R7 Network PTZ Dome Camera Firmware

Version: V5.6.0 Release Note (External)

(2019-03-22)

3.1.3 Configure Multicast Live View Address

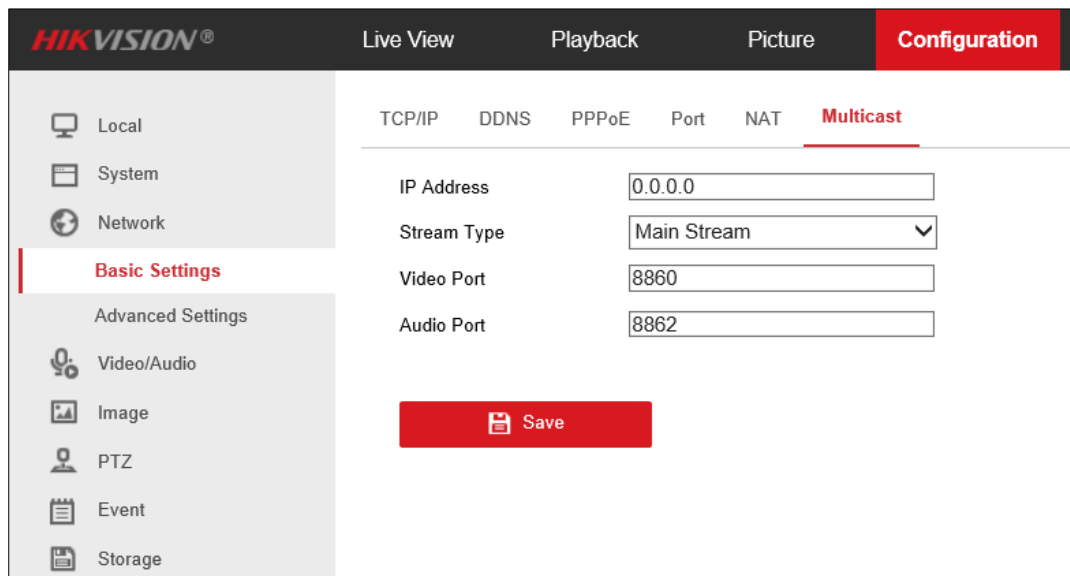
- Configure the multicast address and port on the configuration tab. Different channels and different streams can be configured with their own multicast ports.
- - This feature can only be configured via the web plugin temporarily.

3.1.8 Default Protocol parameters are redefined

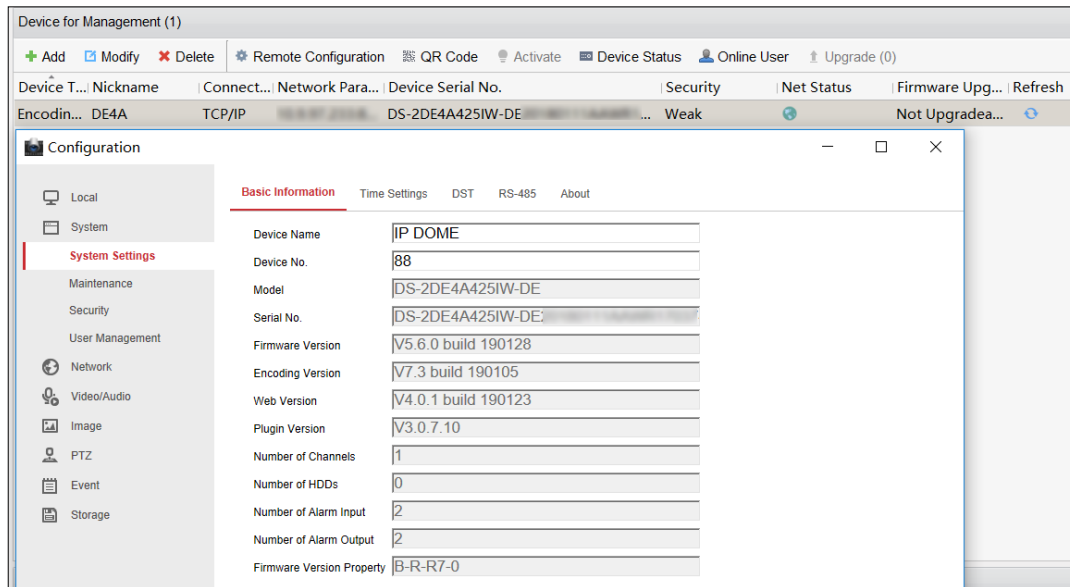
- HTTPS, WebSocket, SDK services
 - Enhanced SDK service is enabled by default. 'Restore' action keeps the parameters as before, while 'Default' would enable the enhanced SDK by default;
 - ONVIF service is not enabled by default, 'Restore' action keeps the parameters as before, while 'Default' would not enable ONVIF by default; websockets is not enabled by default, 'Restore' and 'Default' would not enable the websockets by default.
 - TLS1.1 and TLS1.2 are enabled by default, for both 'Restore' and 'Default' operations ;
 - For old devices upgrading to 5.6.0, maintain the original parameters: if the SDKS did not exist before, the new version is not enabled by default;
 - For the new cameras of 5.6.0, the SDKS (SDK over TLS) service is enabled by default.

3.1.15 Upgrade specific SD cards

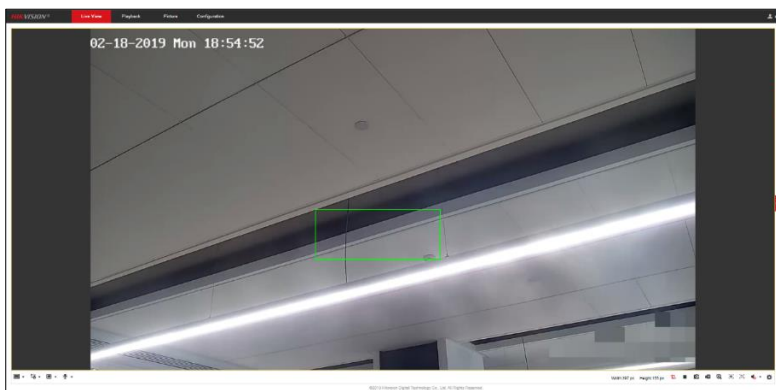
- Specific SD cards could be upgraded through PTZ devices;
- This upgrade is applicable to Hikvision MicroSD card products: L2 series (16G, 32G, 64G, 128G), and H1 series (32G, 64G).

3.1.19 Add Alarm output delay option

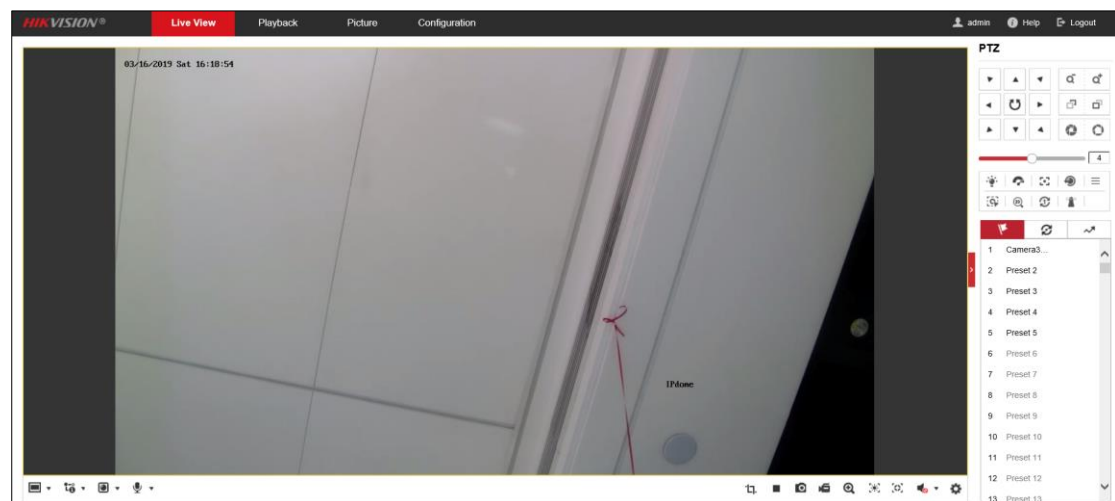
- Add alarm output delay configuration, 5s/10s... were available before, in order to adapt to different application environments, the configuration of 1s is added;
- Alarm output delay can be configured as manual, 1s, 5s, 10s, 30s, 1 min, 2 mins, 5 mins, 10 mins.

3.2.1 Security of Wi-Fi devices is enhanced

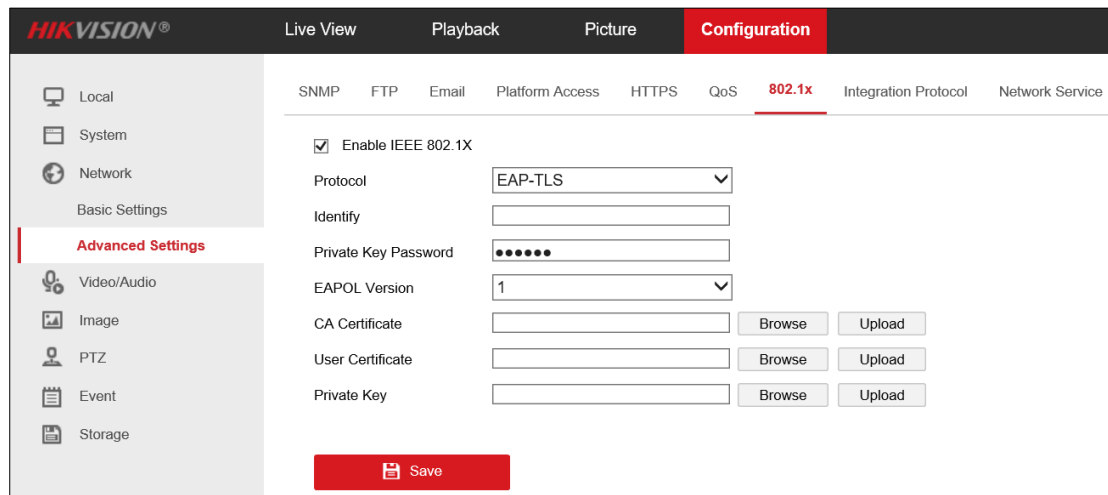
- Wi-Fi component library is update. Wi-Fi could be set to on/off; default is on.

3.2.3 Add 802.1X authentication (EAP-TLS, EAP-LEAP)

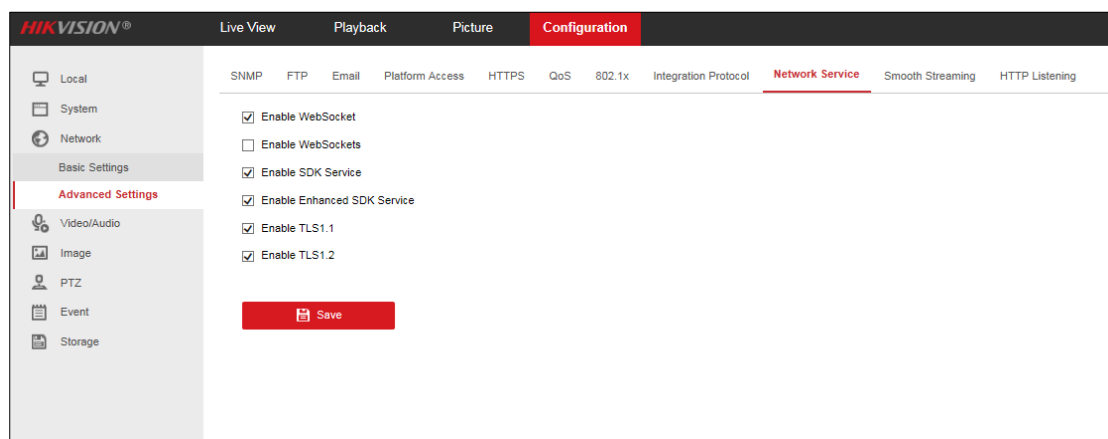
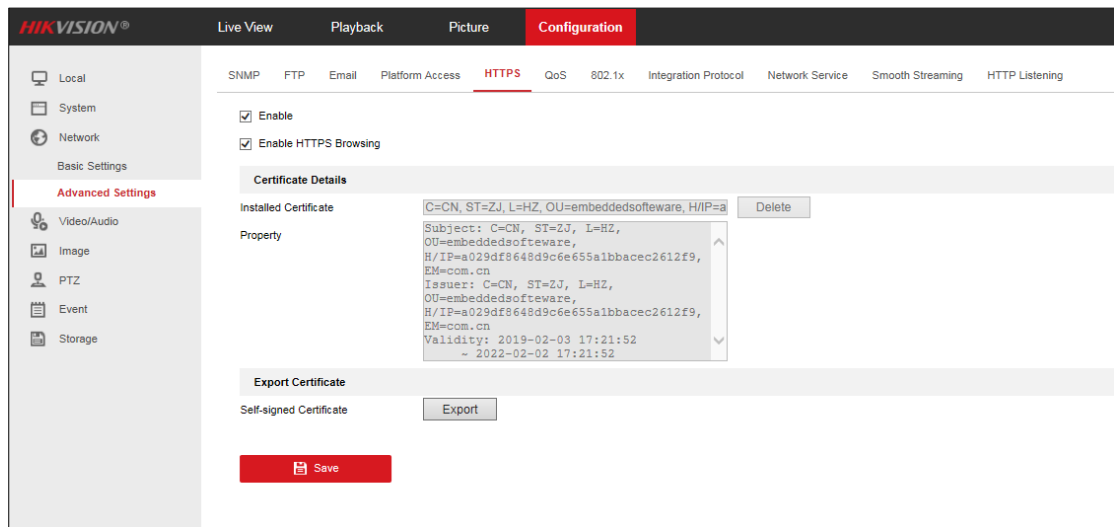
- Add SDK over TLS protocol port configuration. The default port is 8443, with the configuration range 2000~65535. It cannot be duplicated with other protocol ports. The name is an enhanced service port. For the SDK protocol that defaults to port 8000, the logic remains the same;

- SDK over TLS service could be enabled/disabled, and the default SDK over TLS service is enabled (for the 'Default' operation), and the name is to enabling the enhanced SDK service. SDK service could also be enabled/disabled, and the name is enabling the SDK service. 'Restore' maintains the parameters as before;

- When the service is provided through the SDK over TLS, the stream is sent by RTSP;
- The self-signed root certificate could be exported;
- A self-signed certificate is generated on the first boot, and the SDK over TLS service is started via a self-signed certificate. Certificate and https could be reused, without additional SDK over TLS certificate management;

- Device has a self-signed certificate before delivery. At this time, SDK over TLS is enable by default.
- A warning is added when Device certificate is deleted for Websockets, https, and SDK over TLS.
